MEETING NOTICE

TOWN OF BROOKFIELD
PLAN COMMISSION MINUTES
JULY 28, 2026

TO: Town of Brookfield Plan Commission

SHEET NO:
C1.02

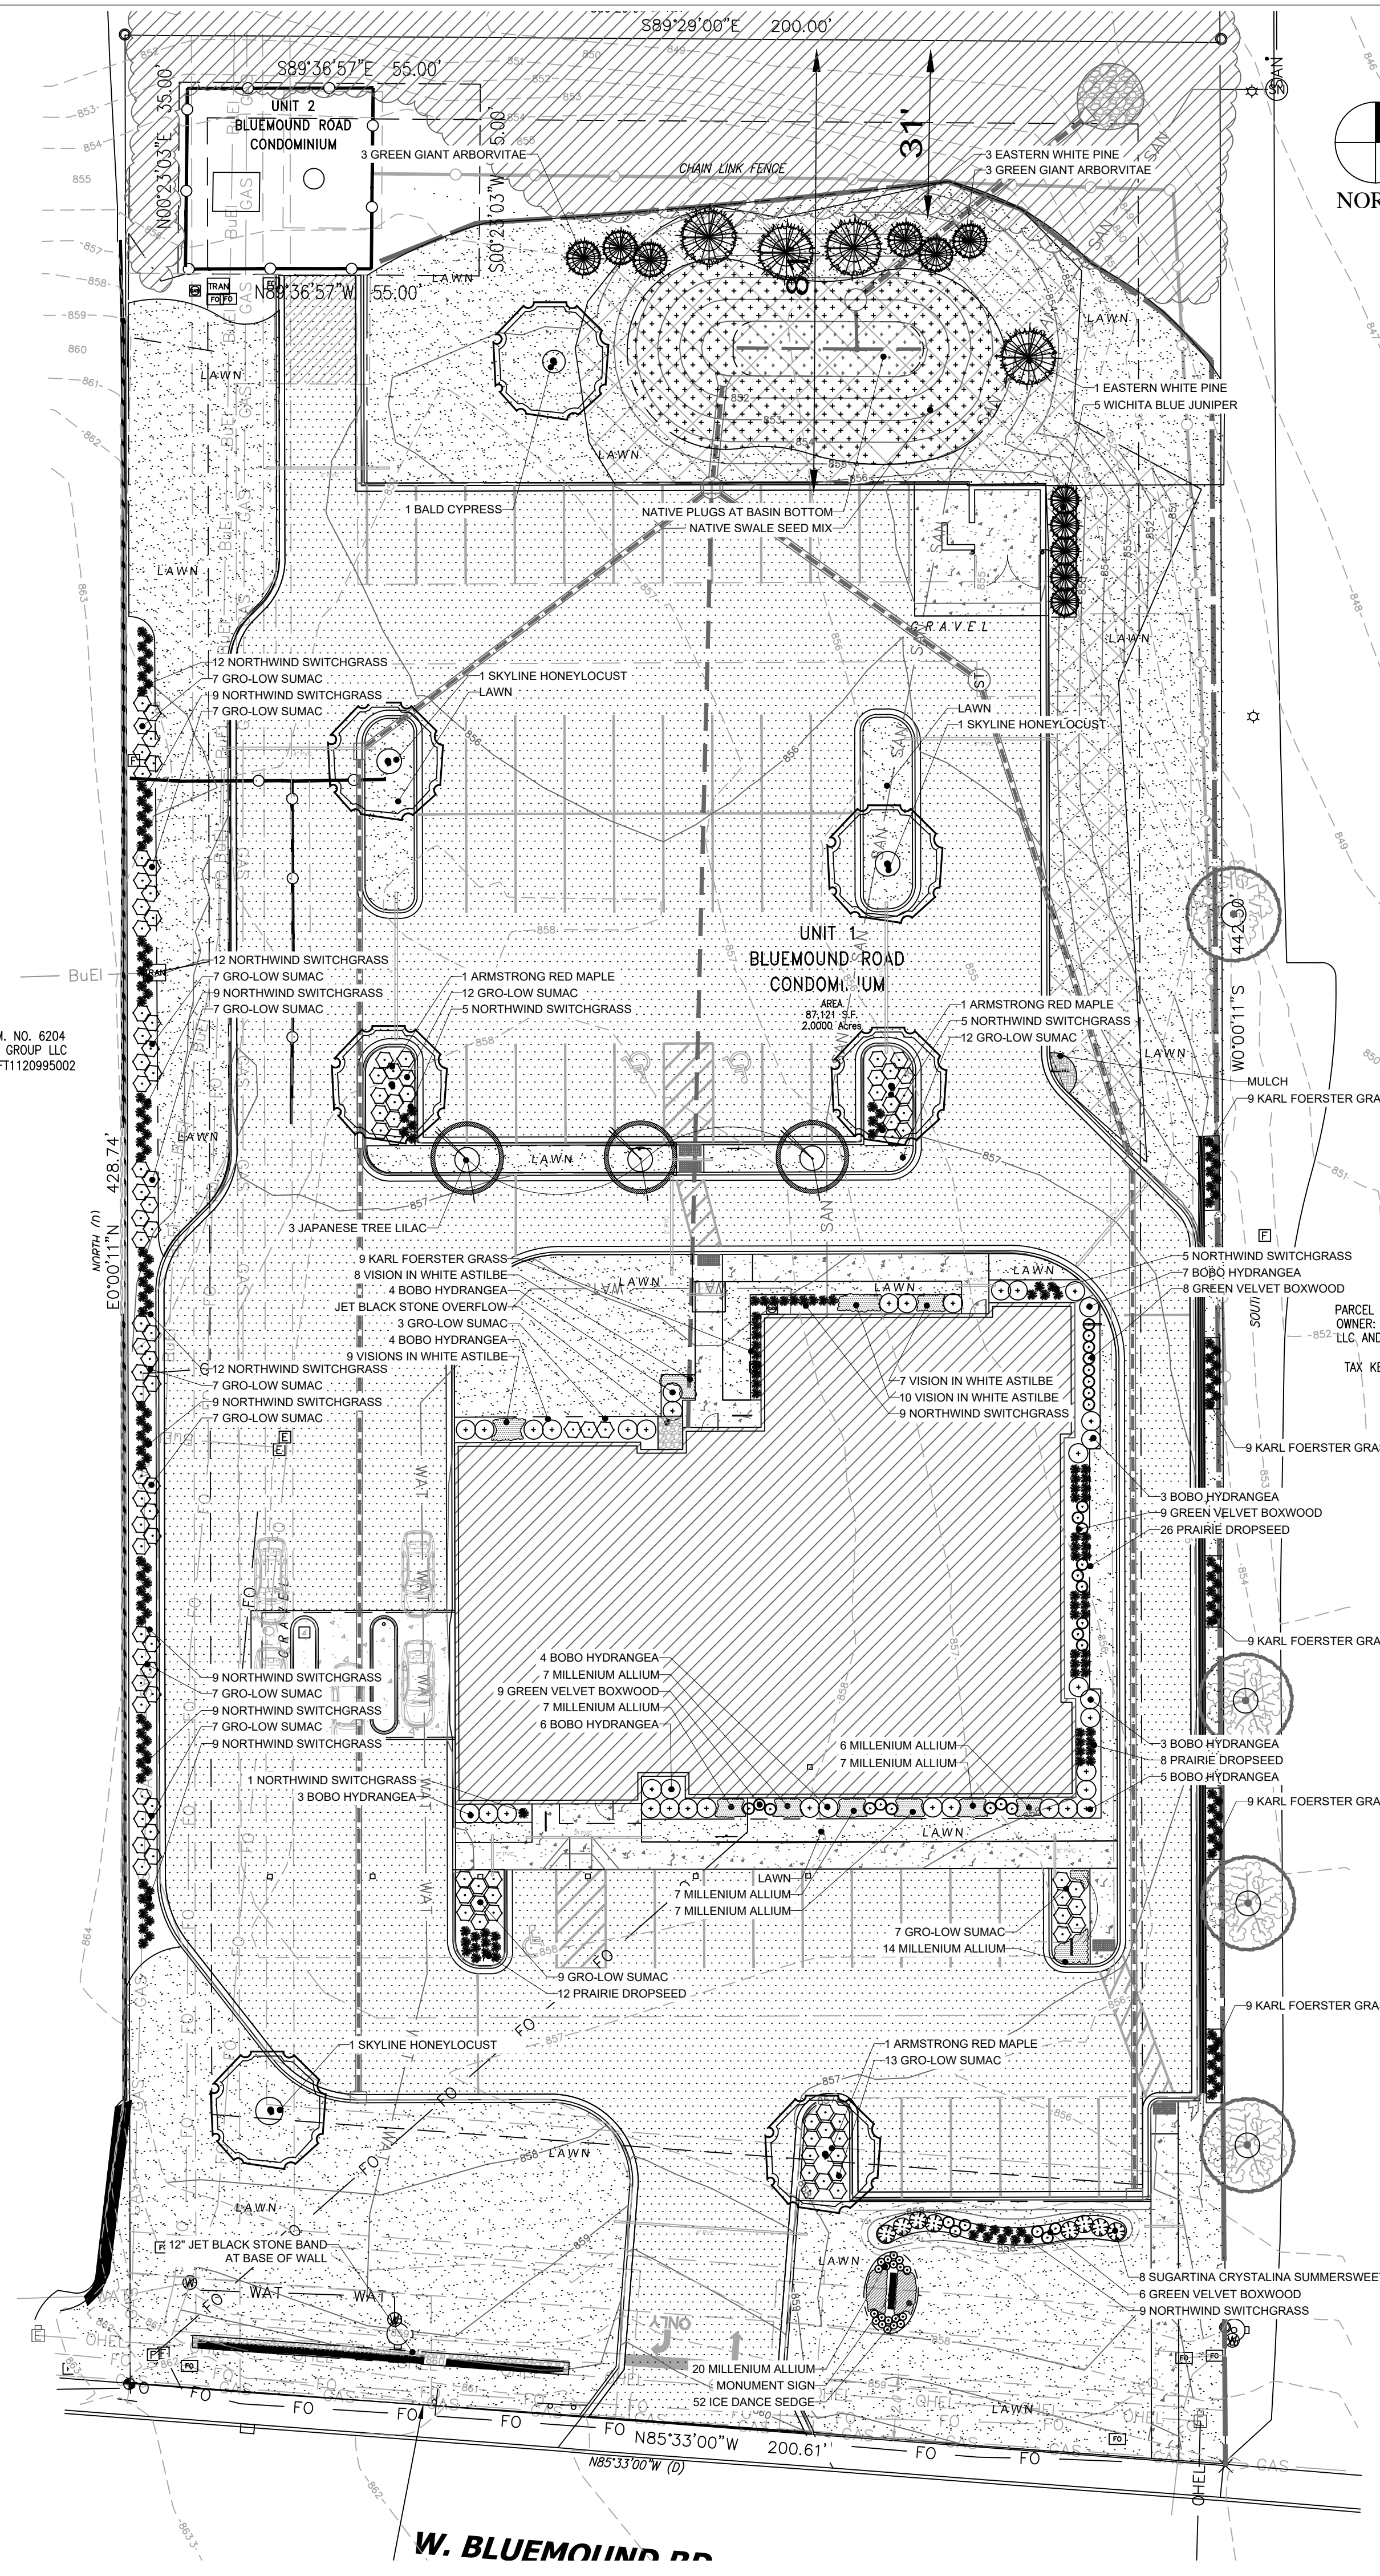
Fire Department: The Fire Department requested additional width along the east drive aisle. The applicant has discussed this with the TBFD. This has required the building to move four feet to the west. Revised plans and turning radius are being prepared; however, the Fire Department noted this will be sufficient.

L 1.0

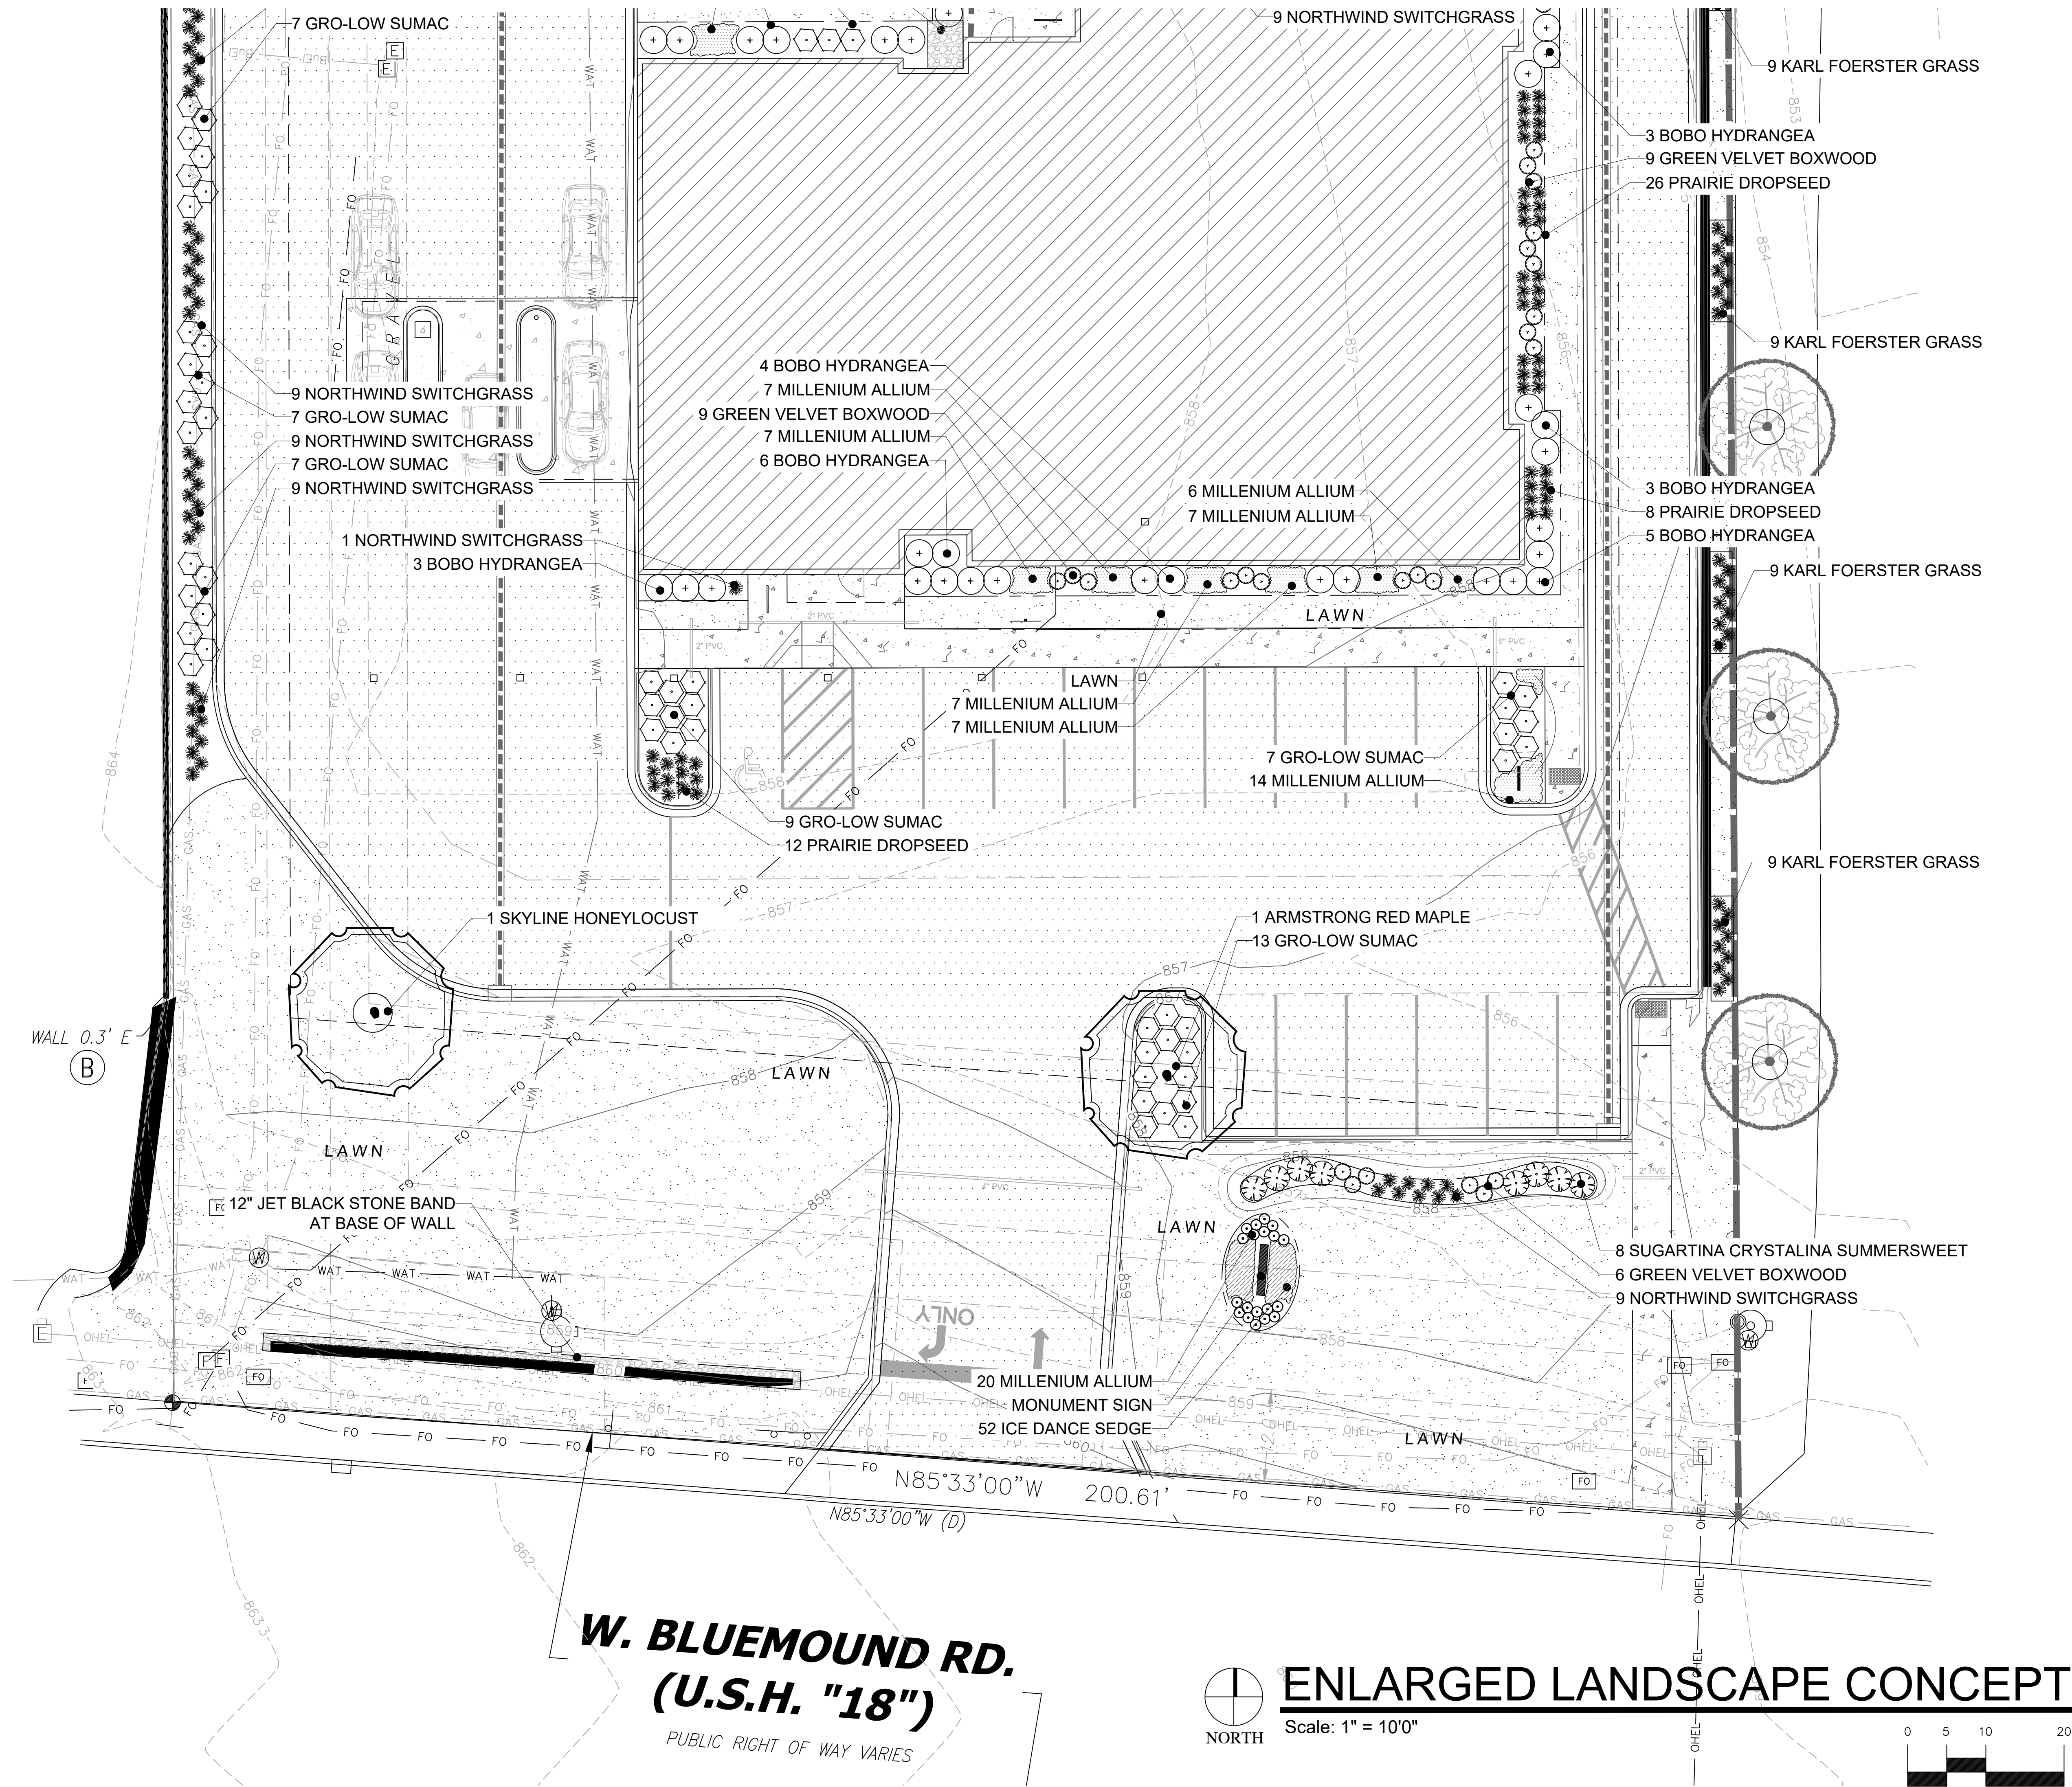
There is landscaping proposed along the perimeter of the building and most of the property. There is also a small landscaping berm south of the customer parking near W. Bluemound Road with additional landscaping. Landscaping around the proposed monument sign is proposed to contain Millennium Allium and Ice Dance Sedge, which are perennials and ornamental grass, respectively. The Town Engineer has made some recommendations to add six additional trees in lawn areas and to shield the cell tower more. Additional recommendations include swapping some species for native species and relocating some of the plants further from the building.

1. A revised sign rendering for the approved monument sign shall be submitted that increased the address numeral letter height to 8 inches.
2. The revised landscaping plan shall be prepared and submitted to incorporate the additional recommendations prepared by the Town Engineer.
